Comparison of County Prel. Weir Analysis Lake Level History to an Independent Analysis

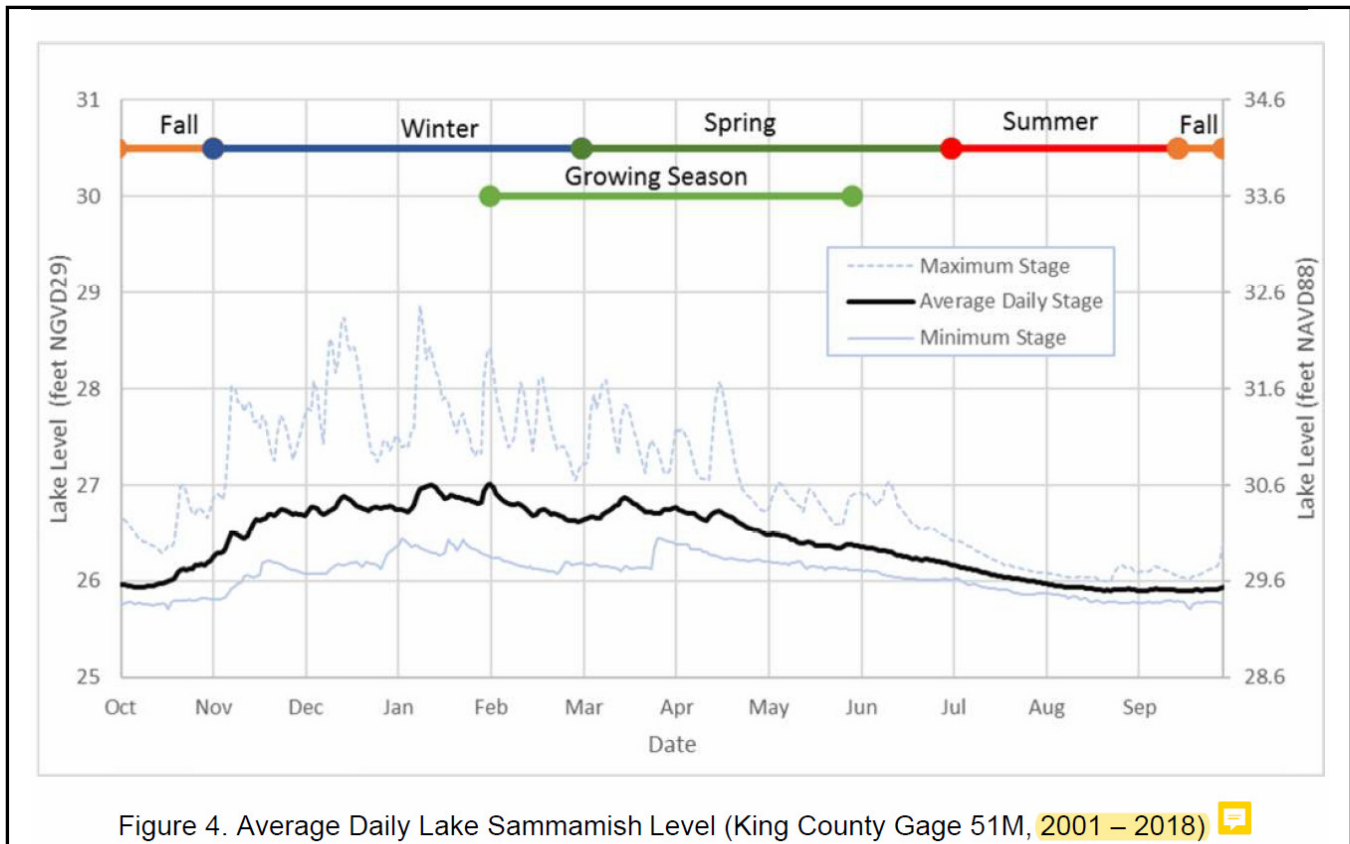
Figure 4, below, is from page 7 of the Willowmoor Preliminary Analysis. It shows few if any days above the historic lake OHHM of 27 ft. NGVD and less than 30 days with average levels exceeding 28 ft.

The following figure was compiled from the USGS gage on Lake Sammamish. A dramatic difference can be seen in comparison to Figure 4, above. The gage's history indicates average levels **exceeded 27 ft. more than 140 days per year**, with the maximum observed levels **exceeding 28 ft. more than 100 days per year**. Analysis of Willowmoor's alternatives would not be accurate if based on Figure 4.
